ACCESSION NBR: 8610160218 DOC. DATE: 86/10/10 NOTARIZED: YES DOCKET #  
 FACIL: 50-410 Nine Mile Point Nuclear Station, Unit 2, Niagara Moha 05000410  
 AUTH. NAME AUTHOR AFFILIATION  
 MANGAN, C. V. Niagara Mohawk Power Corp.  
 RECIP. NAME RECIPIENT AFFILIATION  
 ADENSAM, E. G. BWR Project Directorate 3

SUBJECT: Submits response to comments on changes to FSAR Table  
 421.36-1 re Reg Guide 1.97 submitted in 860919 & 23 ltrs.

Re: Nine Mile Point Unit 2  
Docket No. 50-410

RANGES OF NEUTRON MONITORING SYSTEM

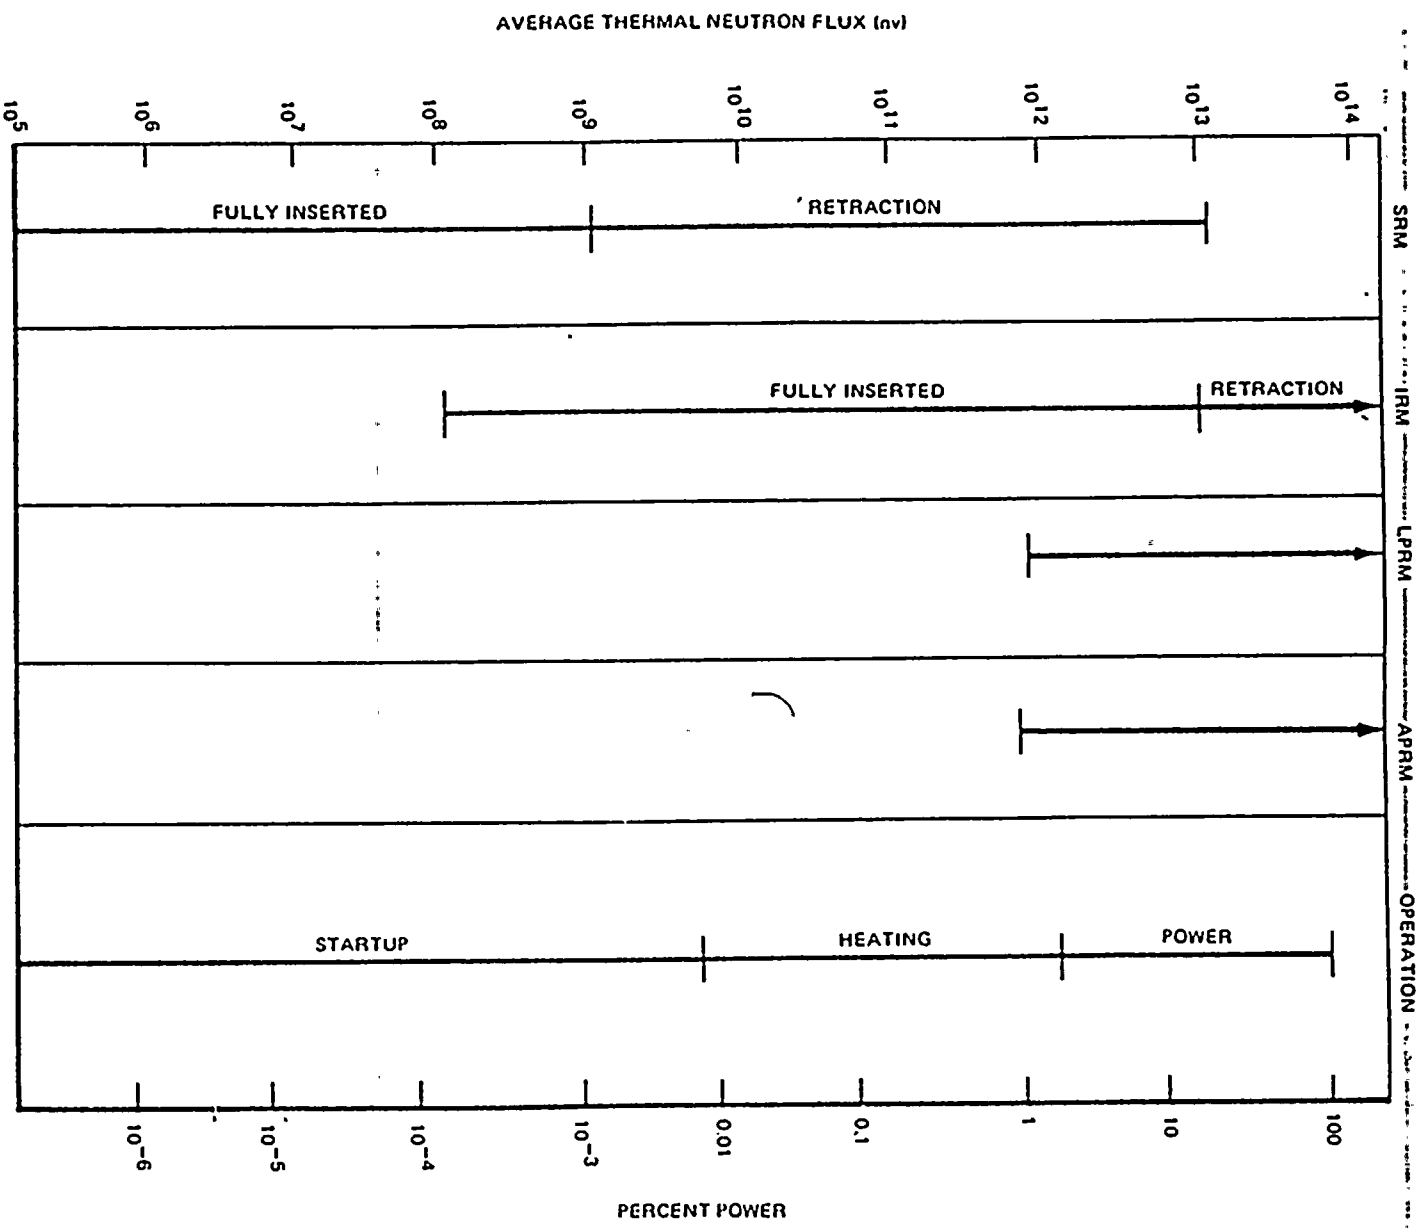
Comment 2) The low end of the intermediate range monitoring instrument was changed from  $4 \times 10^{-5}$  % to  $4 \times 10^{-4}$  % power. Describe how this change complies with the Regulatory Guide 1.97 requirement.

Response 2) Regulatory Guide 1.97 recommended monitoring neutron flux with the range of  $10^{-6}$  % to 100 % full power. Enclosed is Final Safety Analysis Report Figure 7.6-2 which identifies neutron flux detection ranges of the neutron monitoring system. As indicated by this figure, the Regulatory Guide 1.97 recommended ranges are satisfied by the sum of neutron flux ranges from the source range monitor, intermediate range monitor, and power range monitor.

SCHEMATIC DIAGRAM  
 OF RHR HEAT EXCHANGER  
 AND INSTRUMENTATION

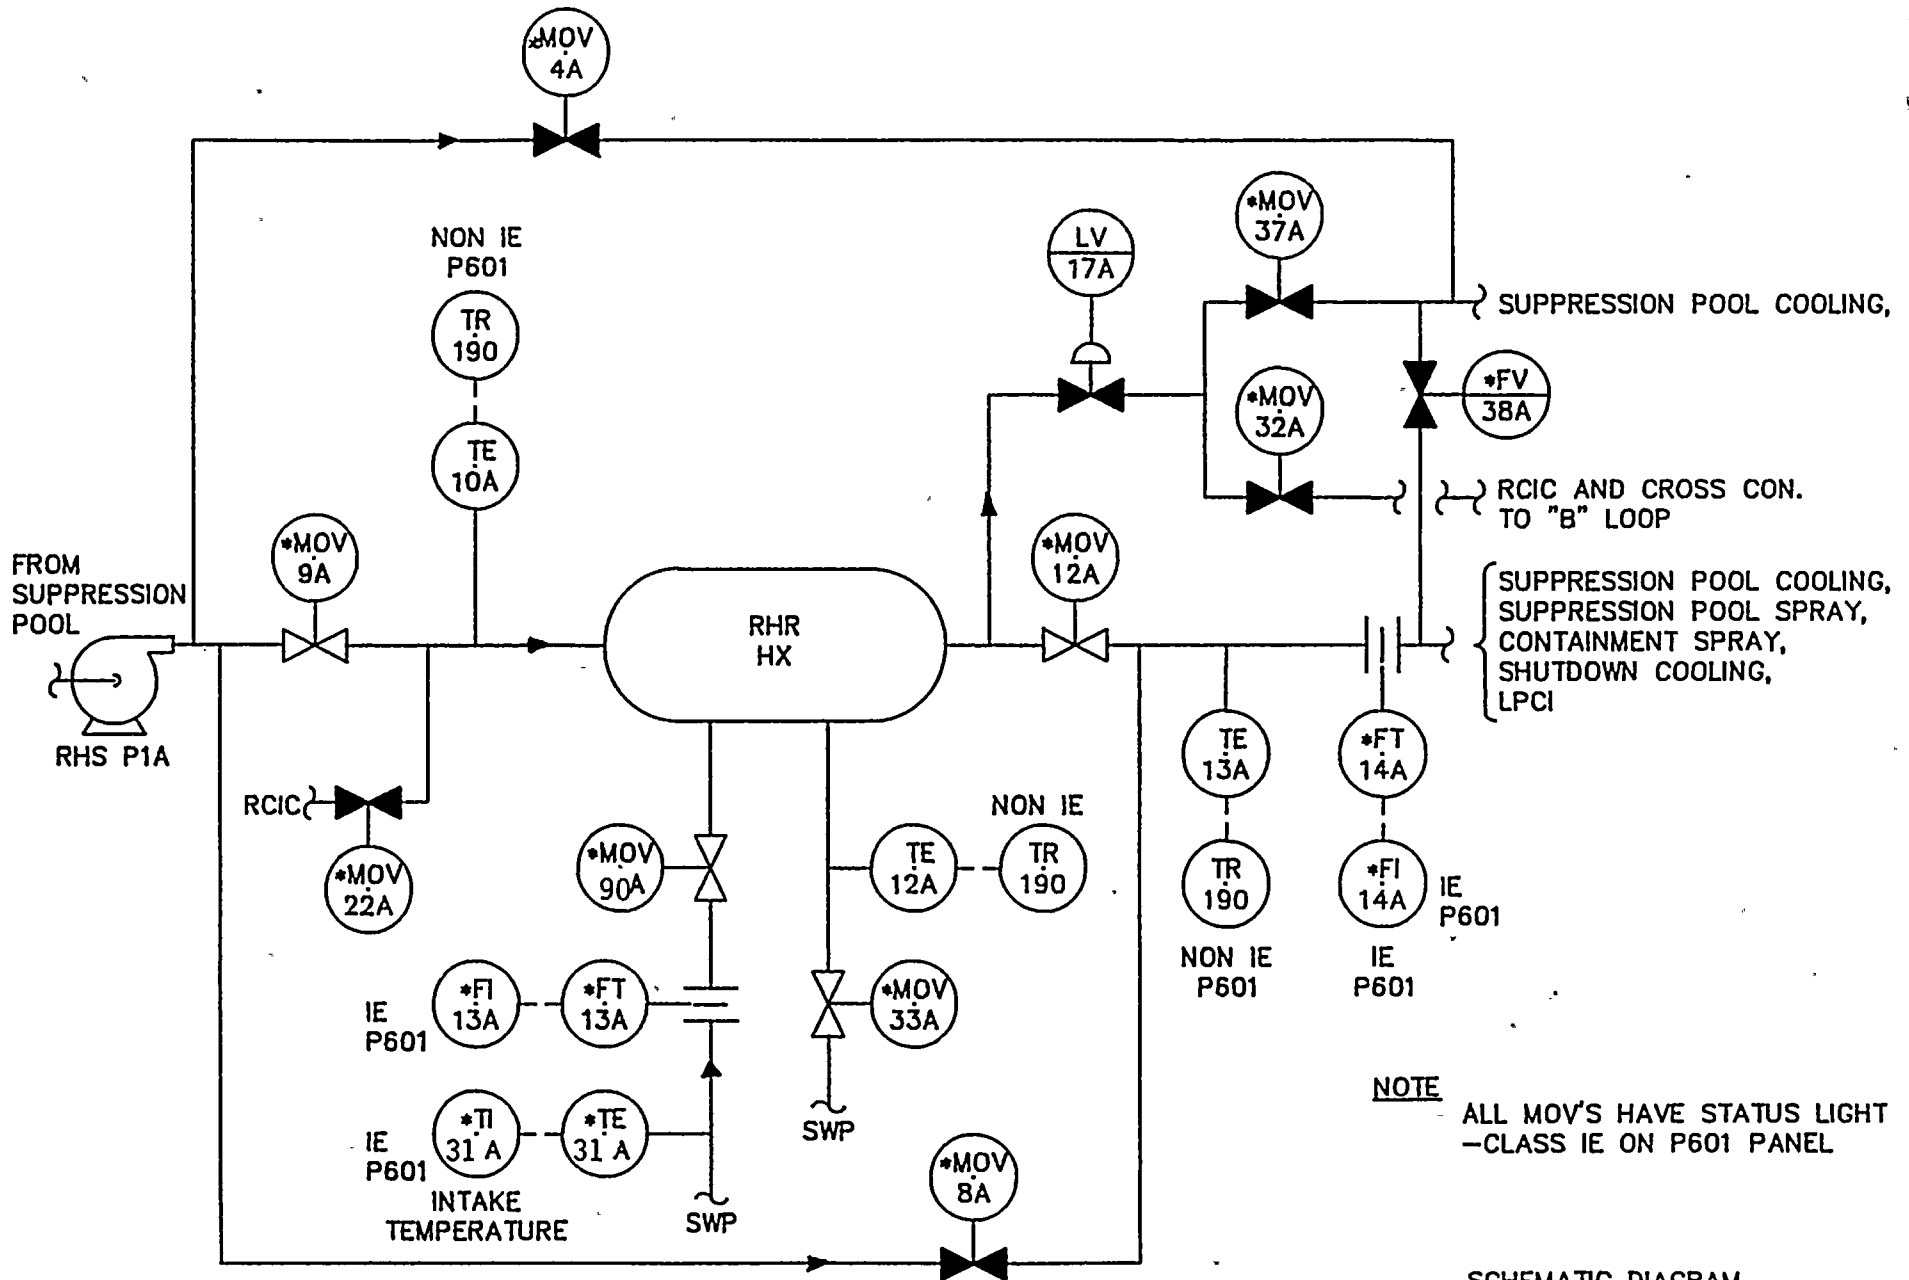
Comment 1) Describe how the RHR Heat Exchanger outlet temperature can be measured by the use of alternate instruments which are qualified to Regulatory Guide 1.97. Also discuss the means of detection if the RHR Heat Exchanger is bypassed.

Response 1) Instruments 2RHS\*TE13A, B measure RHR heat exchangers outlet temperature, which provides an indication of RHR system operation and its effectiveness in removing heat from the primary containment. These instruments are seismically qualified but are not environmentally qualified. These instruments perform no active safety function, thus do not need to be environmentally qualified. Other instruments, provided in accordance with Regulatory Guide 1.97, provide the operator with sufficient information to verify the RHR system is operating and effectively removing heat from the primary containment. These instruments are:

- a. RHR system flow (2RHS\*FT14A, B)
- b. Cooling water flow to ESF components exchangers (2SWP\*FT13A, B)
- c. Drywell/suppression chamber pressure
- d. Drywell atmosphere temperature
- e. Suppression pool water temperature
- f. Drywell spray header flow
- g. Cooling water temperature to ESF components (service water supply temperature - 2SWP\*TE31A, B).

Enclosed is a schematic diagram identifying the instrumentation about the RHR Heat Exchanger. Sufficient information regarding the RHR Heat Exchanger is known to verify performance and bypass. The flow indicator downstream of the heat exchanger verifies RHR flow from the heat exchanger. Valve position indicators verify heat exchanger bypass. A flow indicator in the service water system verifies cooling flow to the RHR Heat Exchanger. As indicated in FSAR Table 9.2-1A and 1B, the service water flow to each RHR Heat Exchanger is 7,400 gpm (total service water flow in each division is approximately 12,623 gpm). This information was submitted by our letter dated August 22, 1986 (NMP2L 0851).

It is therefore concluded that adequate indication of RHR system operation is provided without the instruments 2RHS\*TE13A, B; thereby meeting the intent of Regulatory Guide 1.97, Rev. 3.
